Response to REP5-142 – The Need Case remains unproven

Planning Inspectorate ref: EN020026

Executive Summary

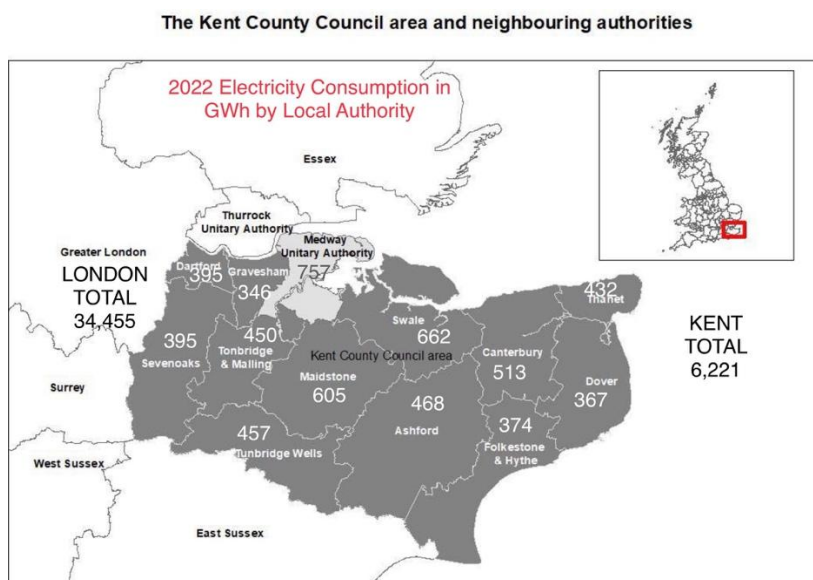
The East 3 option, fully analysed by the Applicant, included the Canterbury North to Kemsley (CAKE) and Bramford to Tilbury (ATNC) upgrades. The East 3 option also included Tilbury to Grain (TENC) but this does not have a proceed signal. However, according to EN020027 APP-357 p46 the *“Tilbury to Grain and Tilbury to Kingsnorth upgrade (TKRE) does have a proceed signal”*.

This gives an additional connection:

Sizewell to Bramford to Tilbury to Grain to Kemsley to Canterbury North.
